Manuscript Number: egusphere-2022-986

Title: Evaluation of a wind tunnel designed to investigate the response of evaporation to changes in the incoming longwave radiation at a water surface

Response to second round of reviews

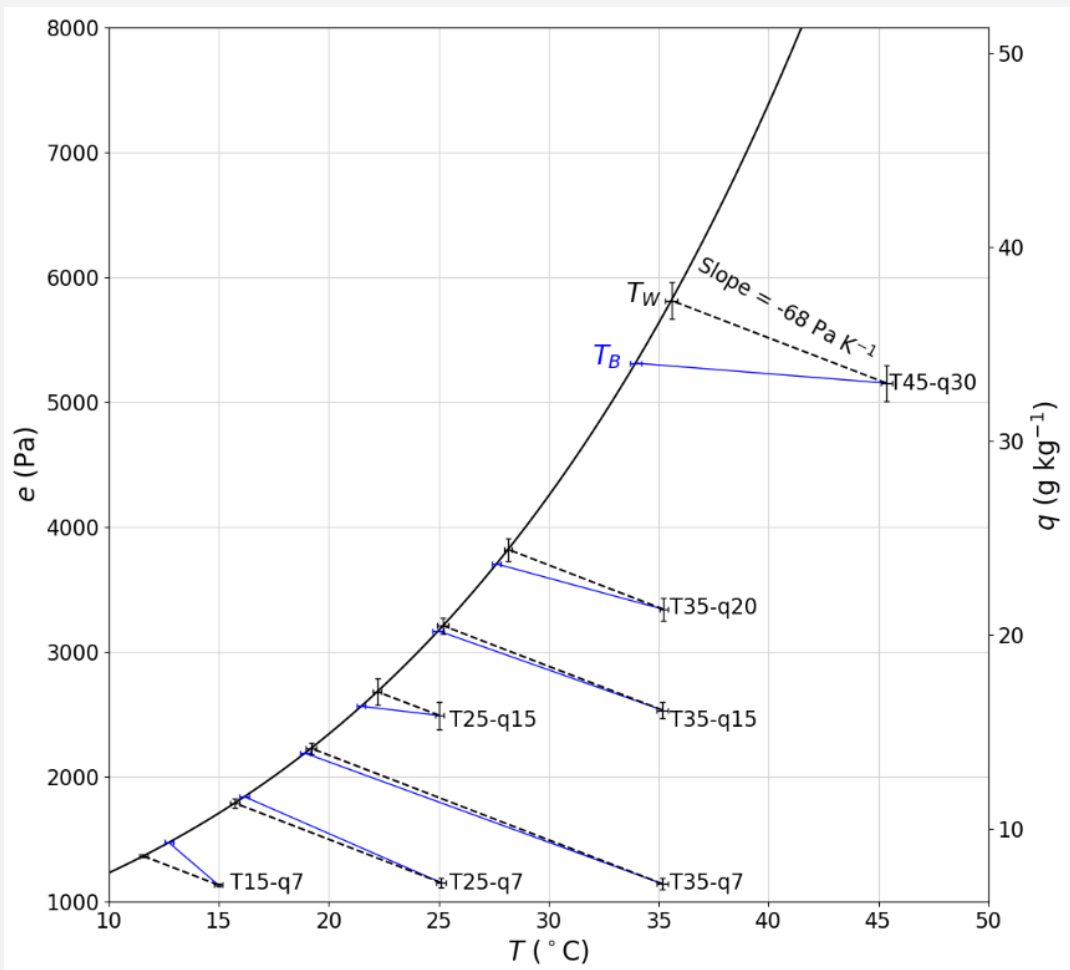
Figure 15: I recommend that the ticks on the left and right axes are matched so that the gridlines are shared; an easy way to do this is to set limits of 1000-8000 Pa for e and 5-40 g/kg for q.

We did not understand this point.

With the limits for e (left hand axes) currently defined as 1000 to 6000 Pa, then the axes on the right (for q) cannot be arbitrarily assigned but is instead set automatically by the underlying physics linking e and q. For example, at 1 bar total pressure the relation between e and q is:

By changing the left hand axes as proposed the plot would look like:

We have left the original plot (Fig. 15) as is.
